**ZONING & PLATTING COMMISSION**  
**SITE PLAN REVISION & VARIANCE REQUEST REVIEW SHEET**

**CASE NUMBER:** C14-83-224(R1)                      **ZAP DATE:** 12/2/2014

**PROJECT NAME:** Pinnacle at Great Hills

**VARIANCE REQUEST:** To allow driveway construction on a slope greater than 25 percent to areas of slope not less than 25 percent. Lake Austin Watershed Ordinance Section 29-55.3(a)(1).

**Site Plan**  
C14-83-224(R1)

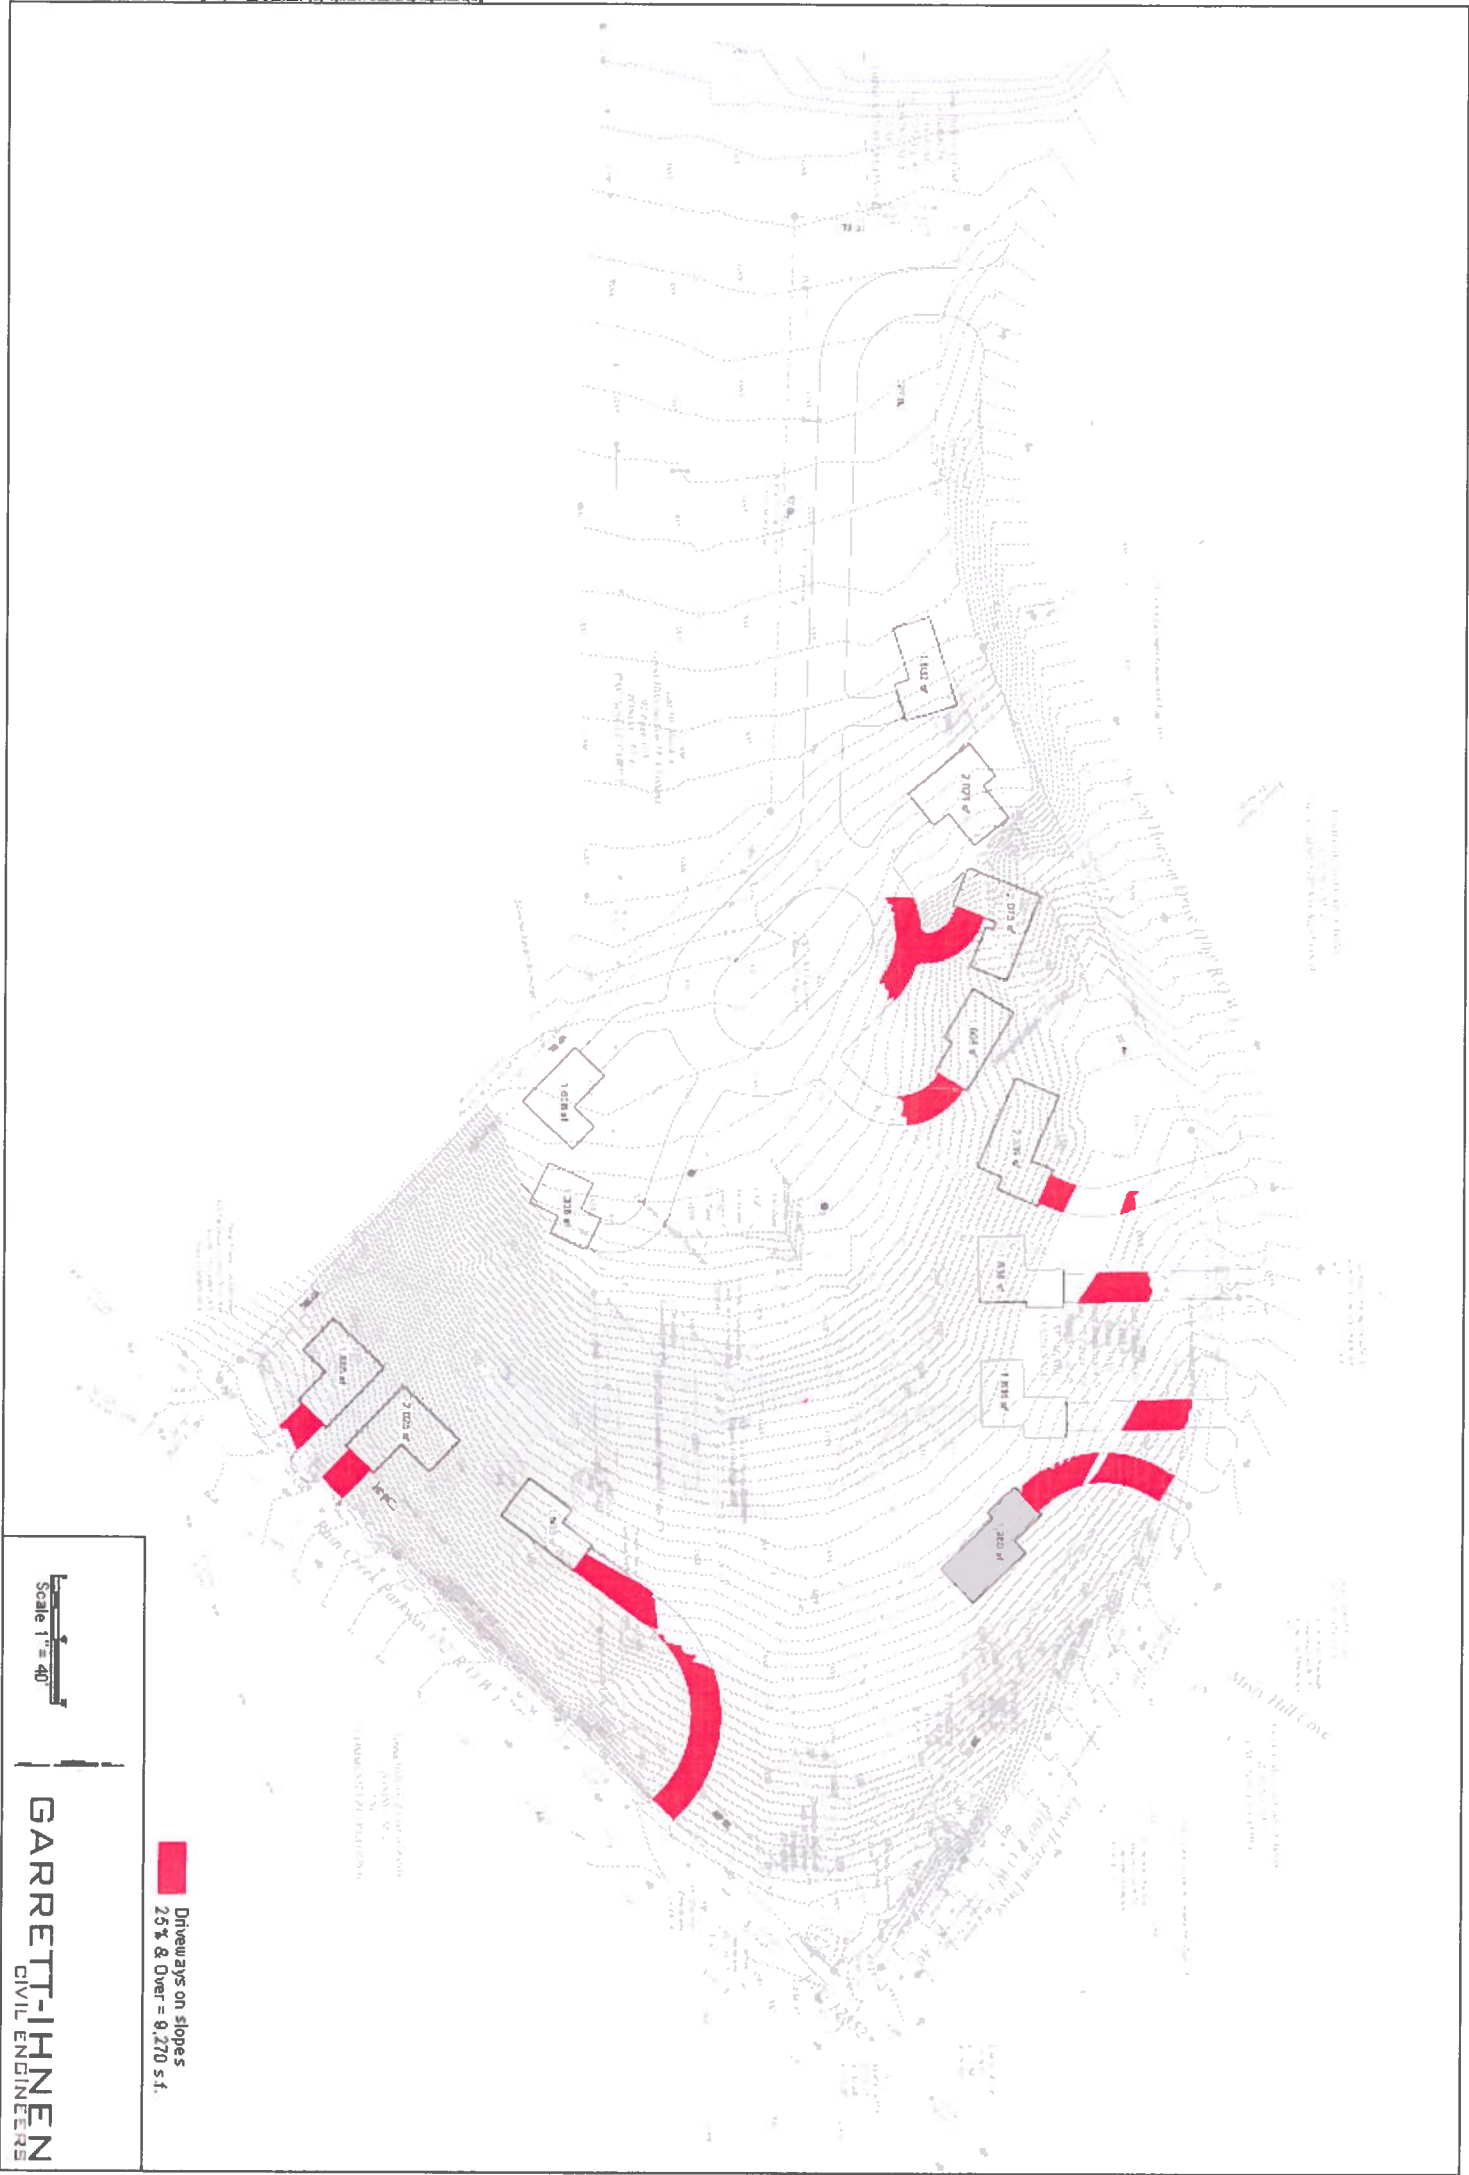
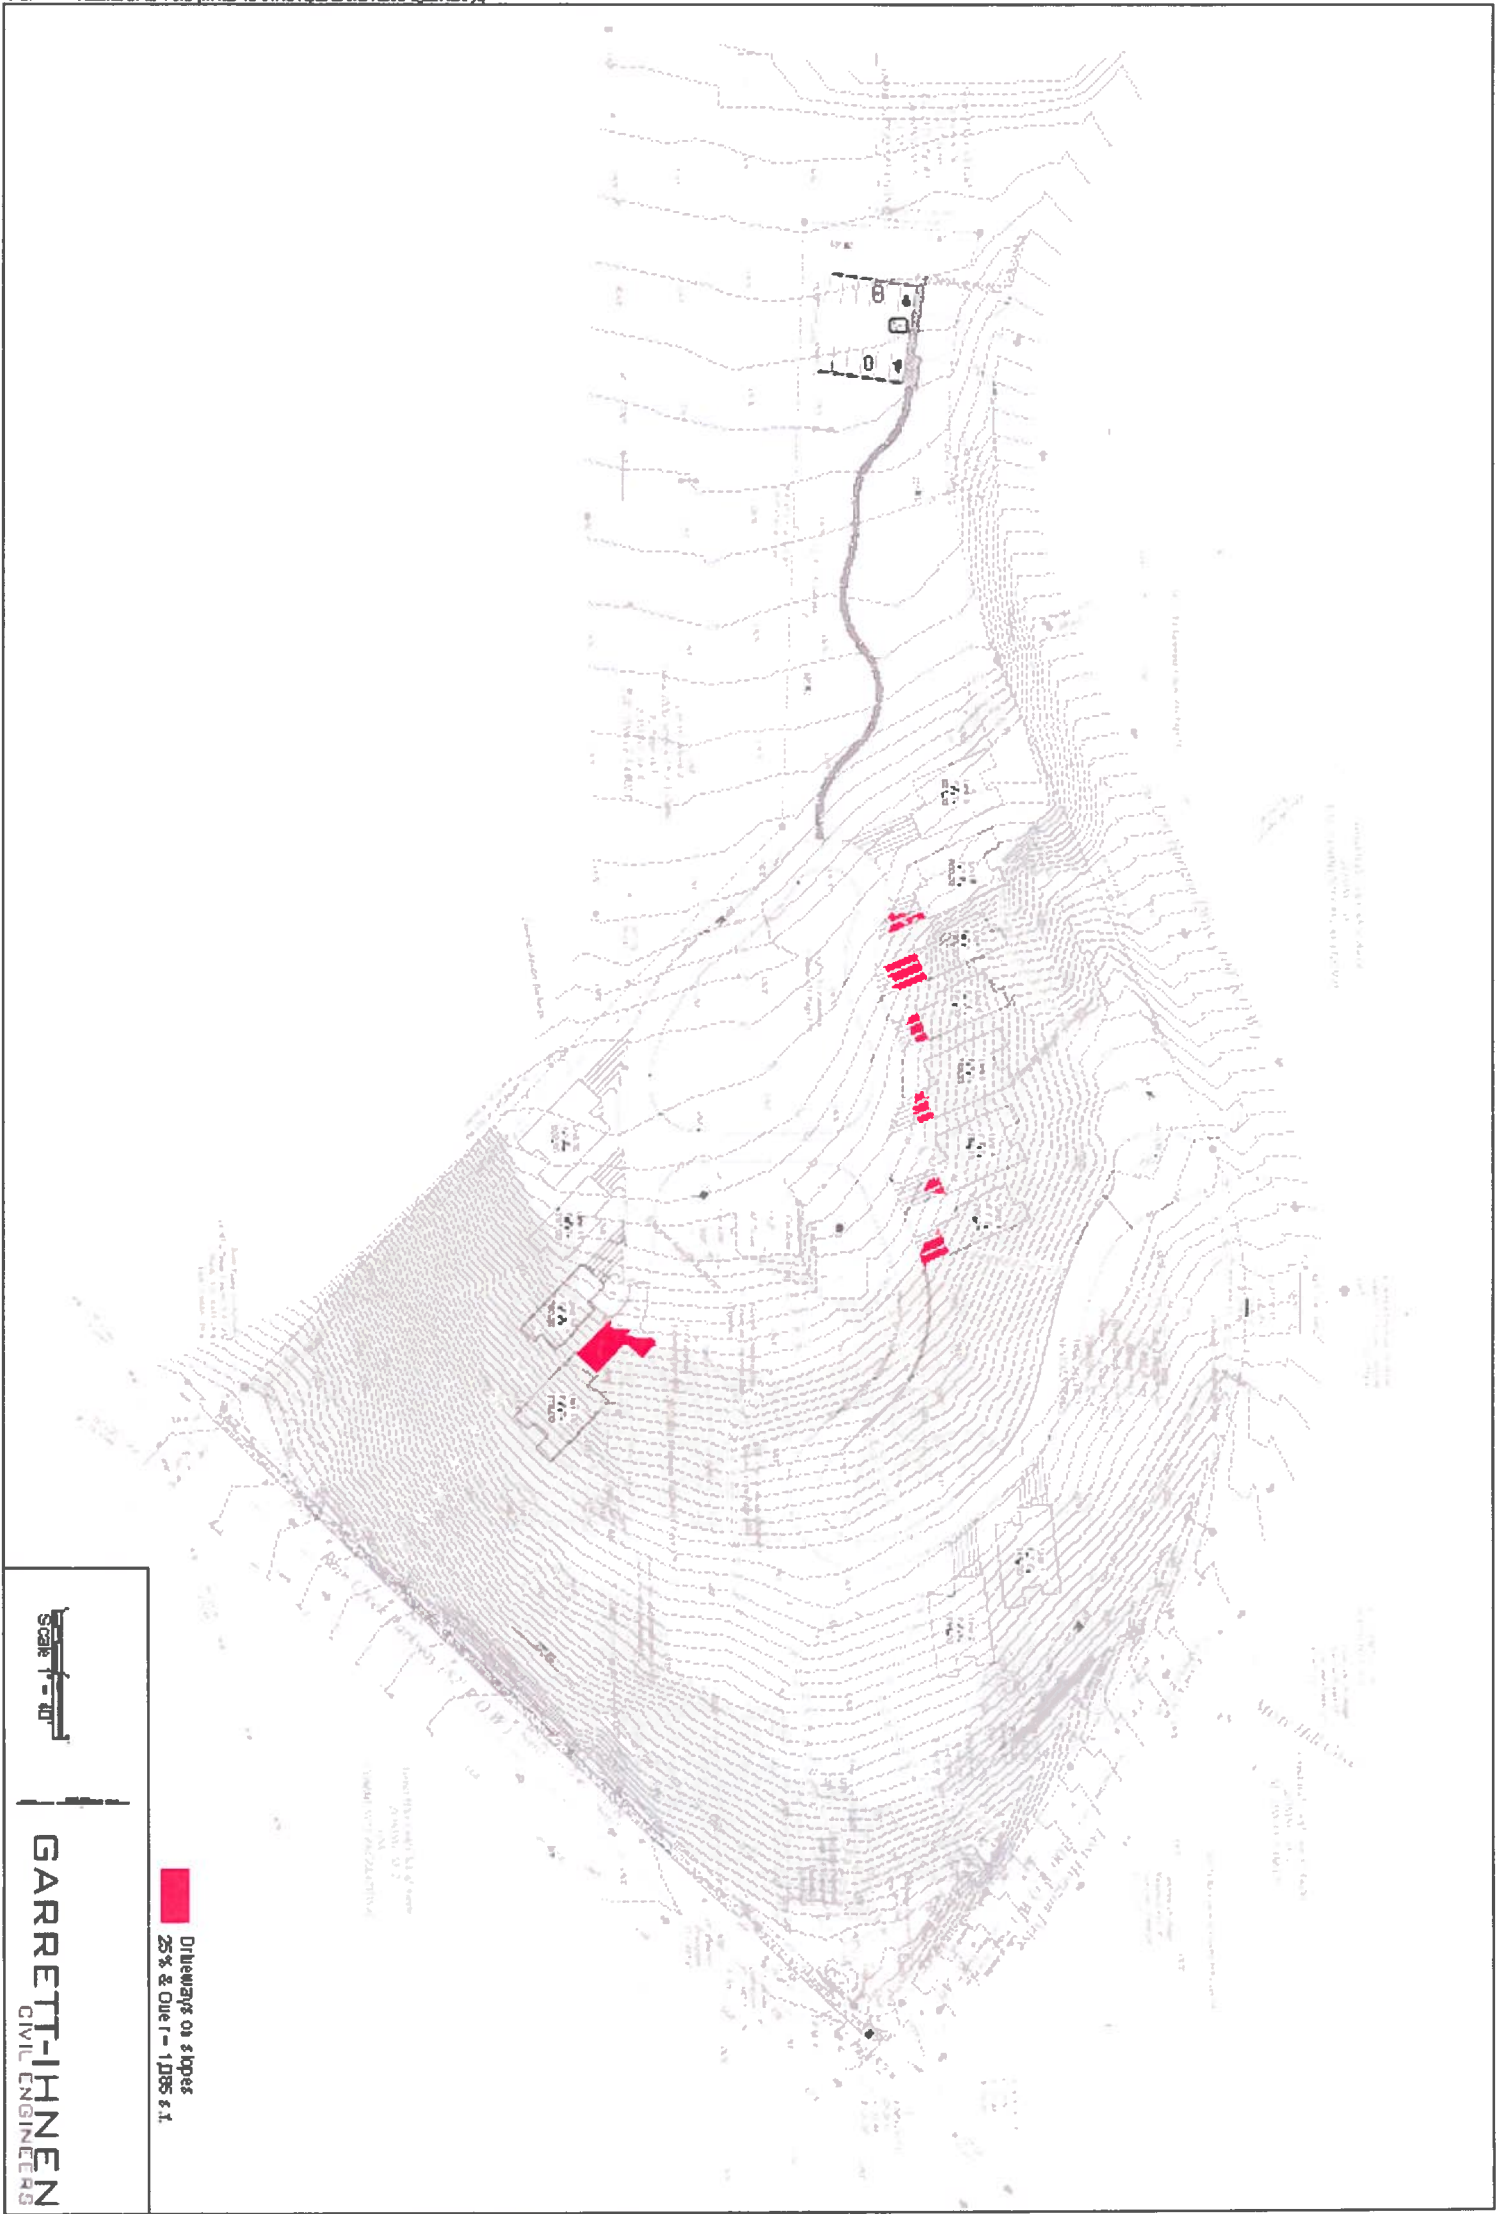
1. Reduces the area of construction of driveways on slopes greater than 25% from the Council approved plan from 9,270 sf to only 1,085 sf (88% reduction);
2. The variance request impacts less than 0.7% of the total site slopes greater than 25%.
3. Reduces the number of unites accessed by driveway over slopes greater than 25% from 9 units to 7 units;
4. Reduces area cut and fill in excess of 4' to zero;
5. Reduces the overall impervious cover from 66,492 square feet to 59,692 square feet;
6. Reduces the number of driveways from eight to two;

- Area of Driveway Constructed on Slopes > 25% = 9,270 sf
- Units Accessed over Slopes > 25% = 9 Units

- Proposed Replacement Site Plan C14-83-224(R1)
- Area of Driveway Constructed on Slopes > 25% = 1,085 sf
- Units Accessed over Slopes > 25% = 7 Units
